VILLAGE PLAN COMMISSION AGENDA

Village of Kimberly Request for Plan Commission Recommendation

ITEM DESCRIPTION: Planned Unit Development Amendment – Lot 27 of Rivers Edge Subdivision

Proposed Development: Rivers Edge Lot 27

FOUNDATION PLAN
 1/4" = 1'-0" WALL HEIGHT: 4'-0"

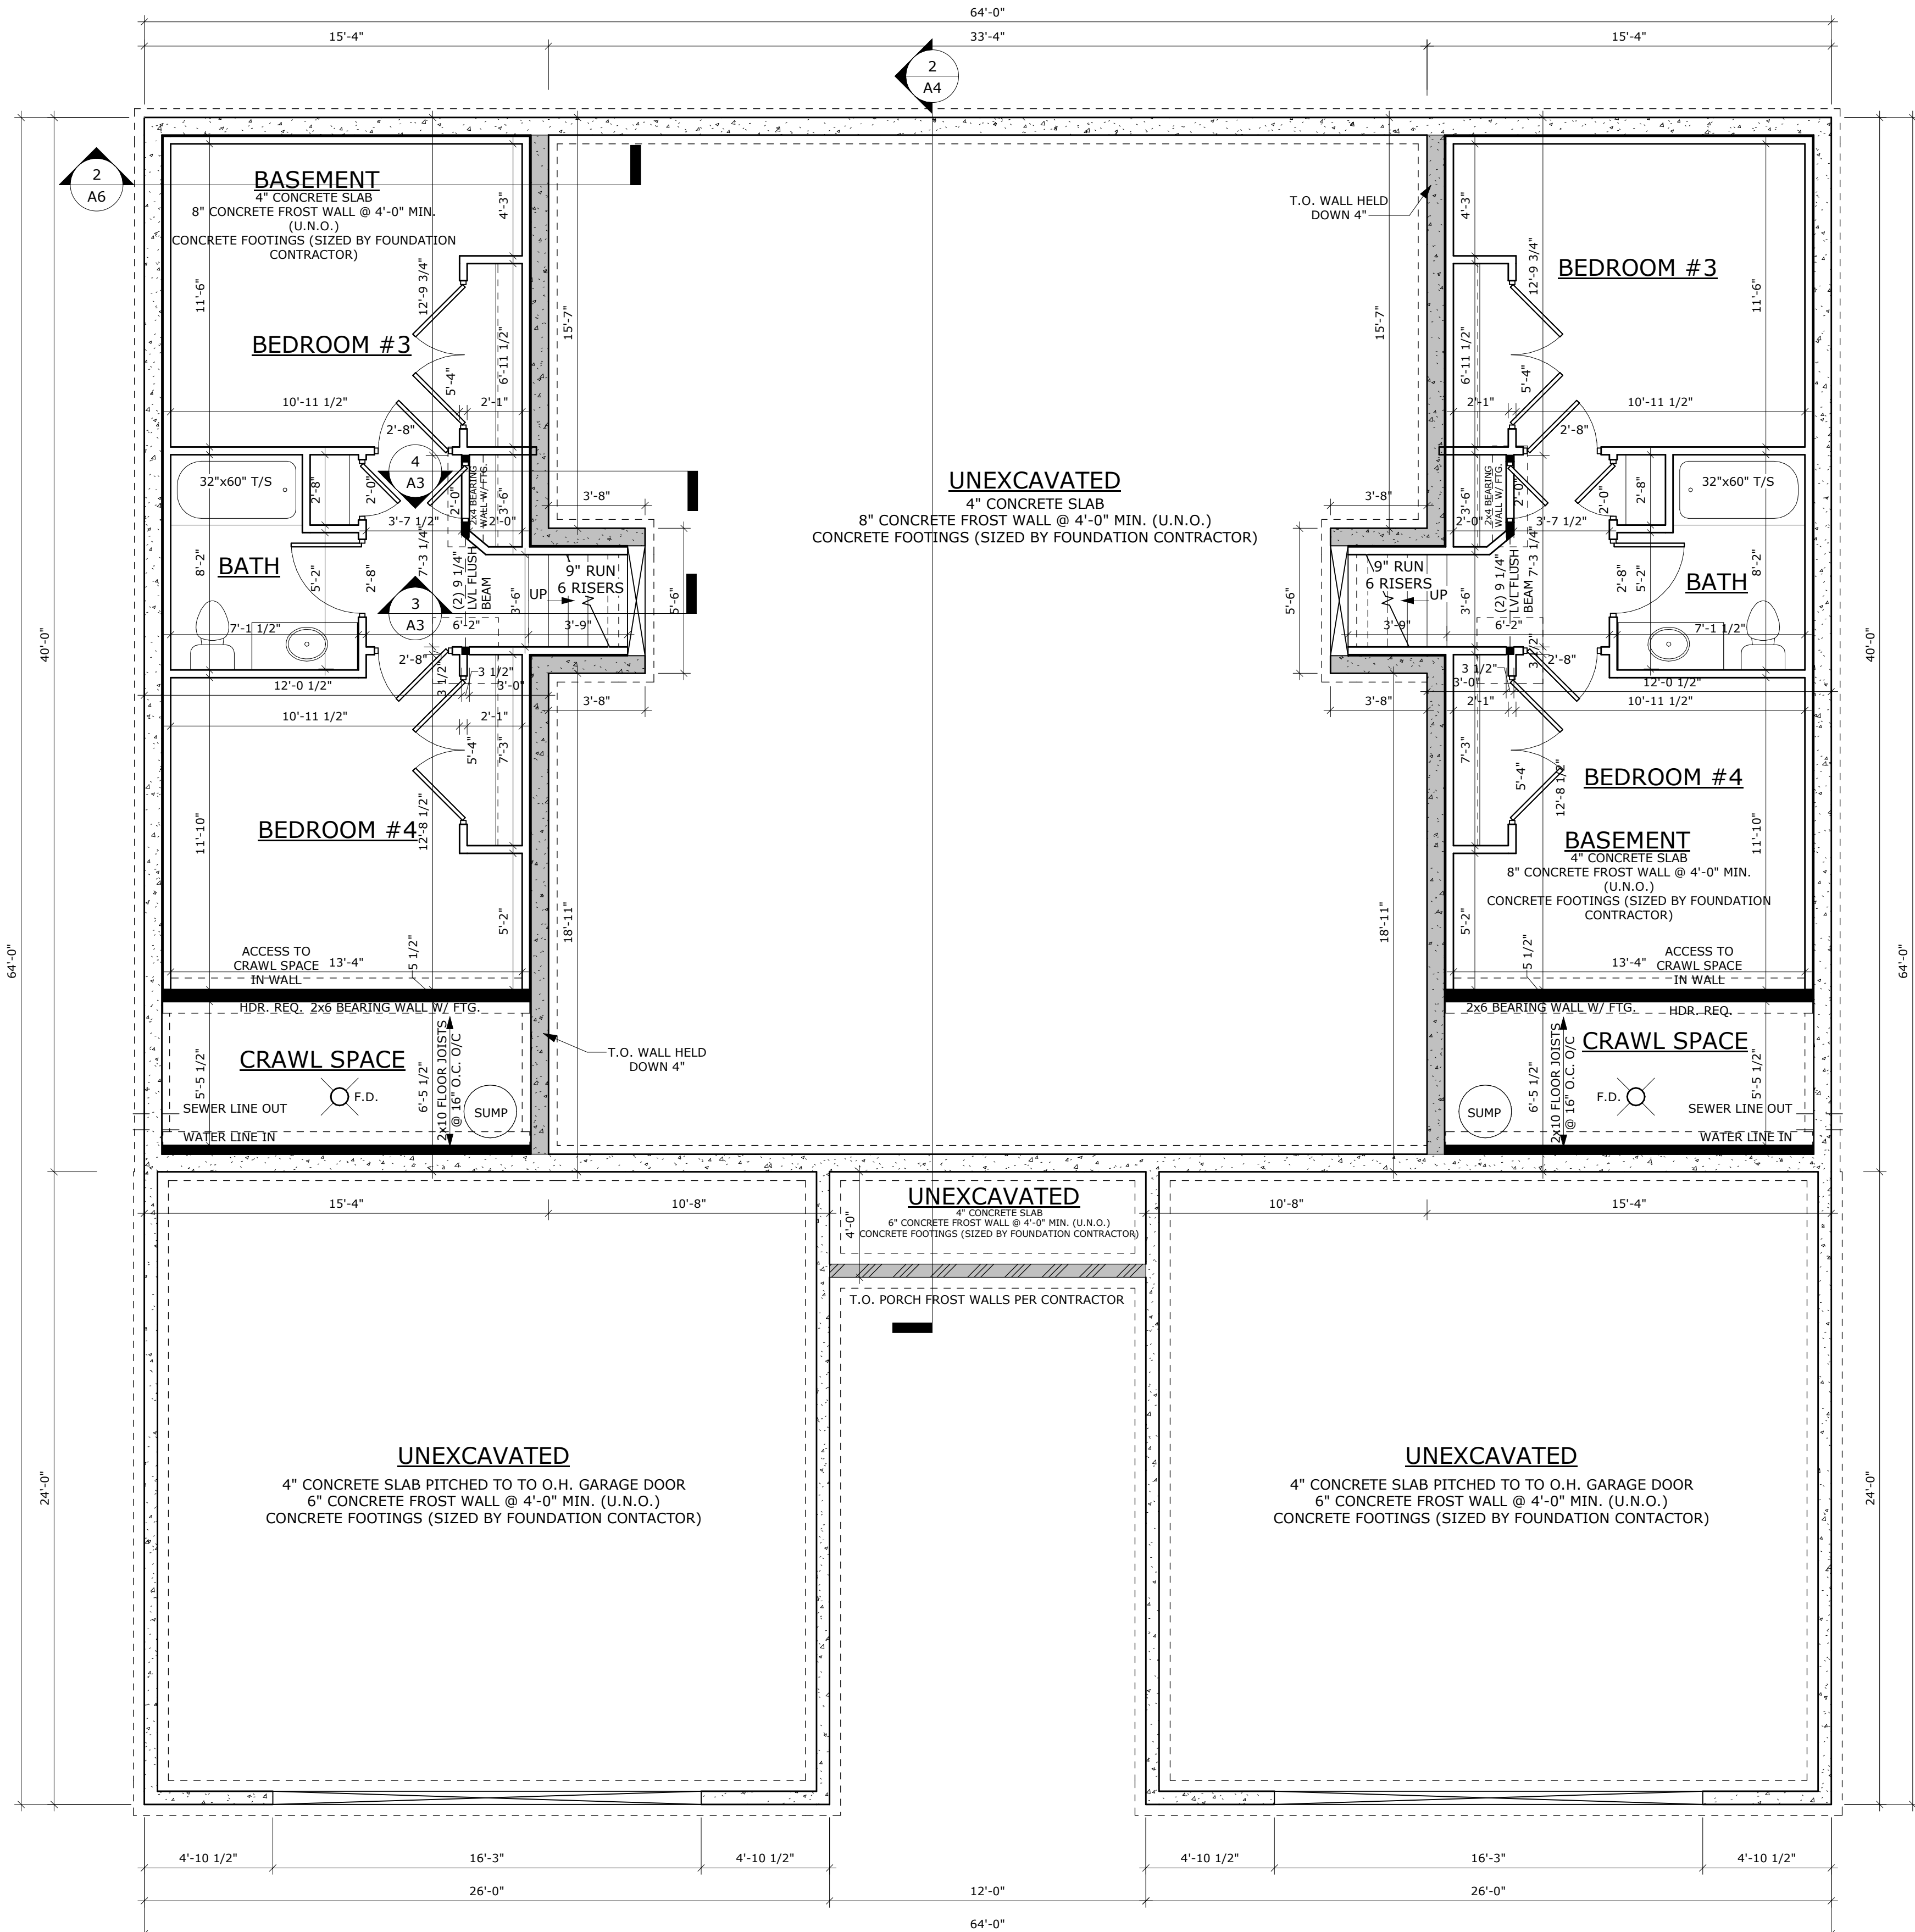
1. Additional architectural elements such as stone, brick, board and batten or shake shall be added to the building in both the front and rear facades of the dwellings to better fit with the surrounding development.
2. Minor modifications to the principal building shall be permitted upon review by the Village staff.
3. The principal building shall be setback a minimum of 25 feet from the adjacent properties.

**SITE & LANDSCAPE
PLAN LOT 27**
BOSTAD BUILDERS

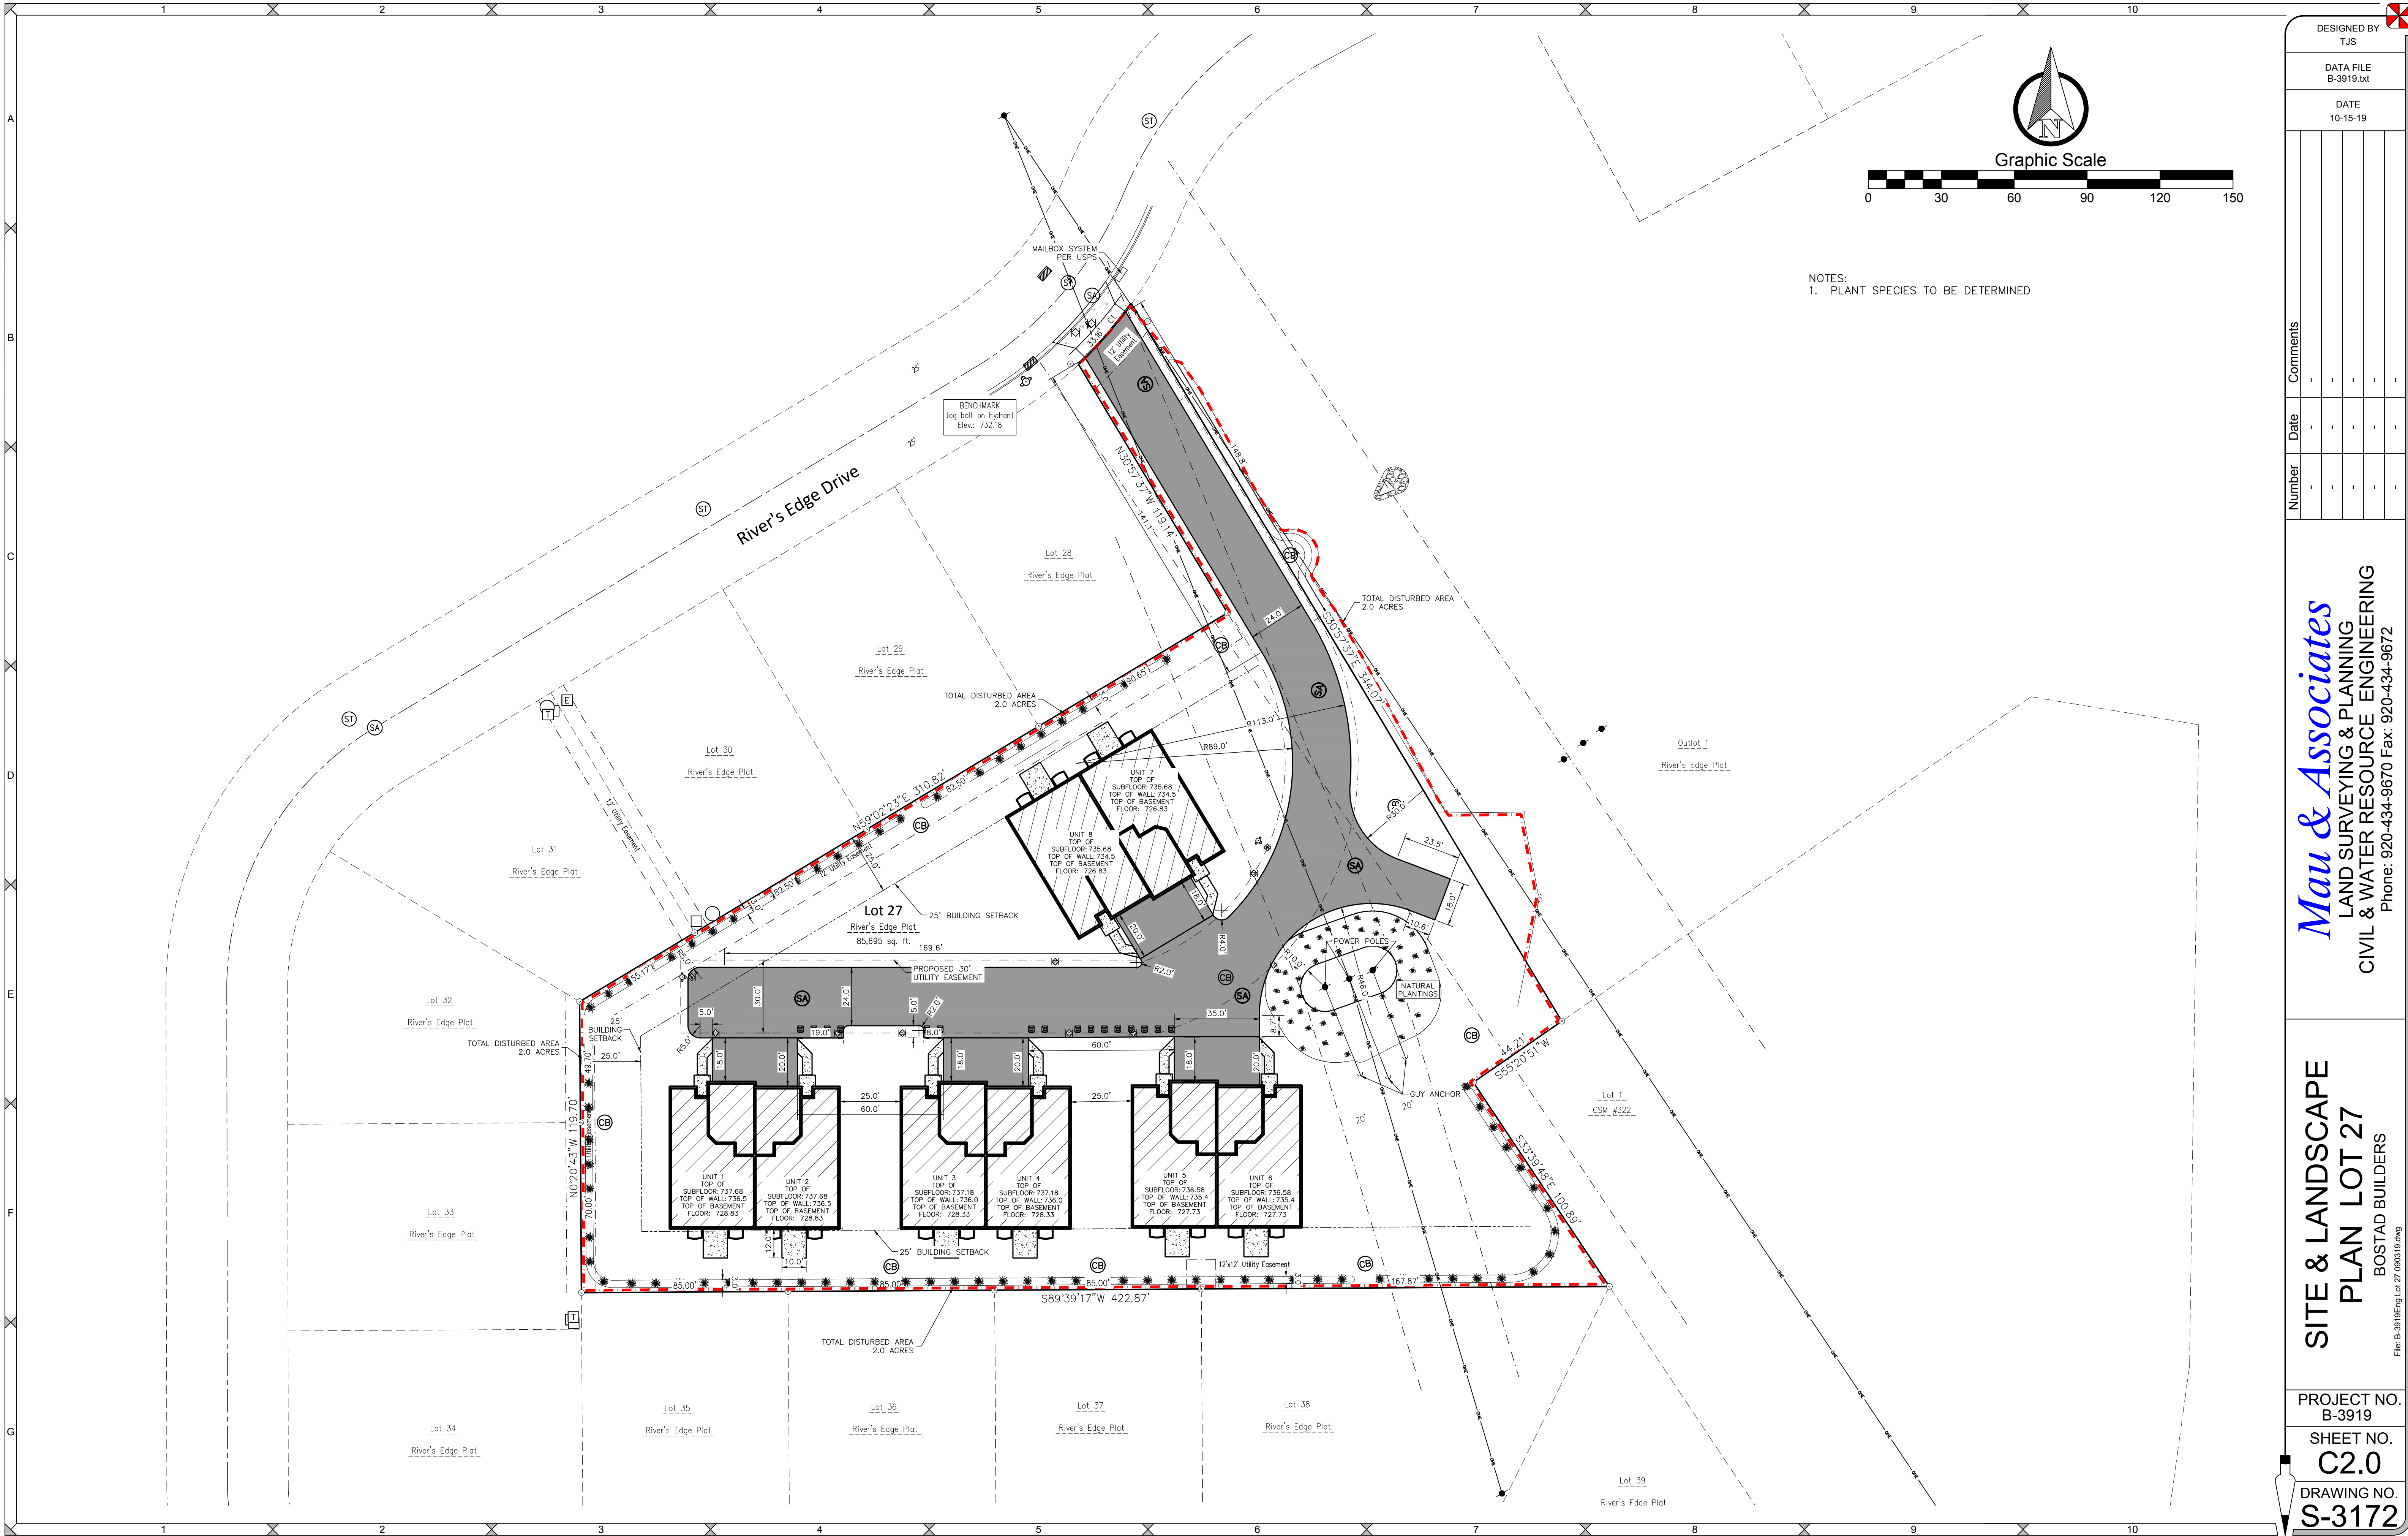
RECOMMENDED ACTION: Staff recommends approval of the development plan, civil and architectural plans, as proposed subject to the following conditions in addition to any Plan Commission might identify: Conditions: 1. Approval includes the reduced setbacks as shown on the plans. 2. Approval includes ability to employ 13 foot setback to the north and south property lines for additions not to exceed 12 feet x 12 feet. 3. Secure Village and state agency approval of water, sanitary and storm utility plans prior to the construction of each of these utilities. 4. Secure Village approval for the Water Main easement.

5. Secure Village approval of a standard construction detail for the private road.
6. The Site Layout plan shall include a summary of impervious square footage.
7. The developer shall provide a signed copy of the Garbage & Recycling Collection Waiver and Hold Harmless agreement.
8. Submit and secure approval of a detailed Landscaping Plan by (date or benchmark to be identified.)
9. Landscaping berms shall be installed in a manner to promote the flow of storm water along shared property lines with abutting properties.
10. Post addresses at the private drive entrance.
11. Submit and secure approval of any development signage prior to issuance of a building permit.
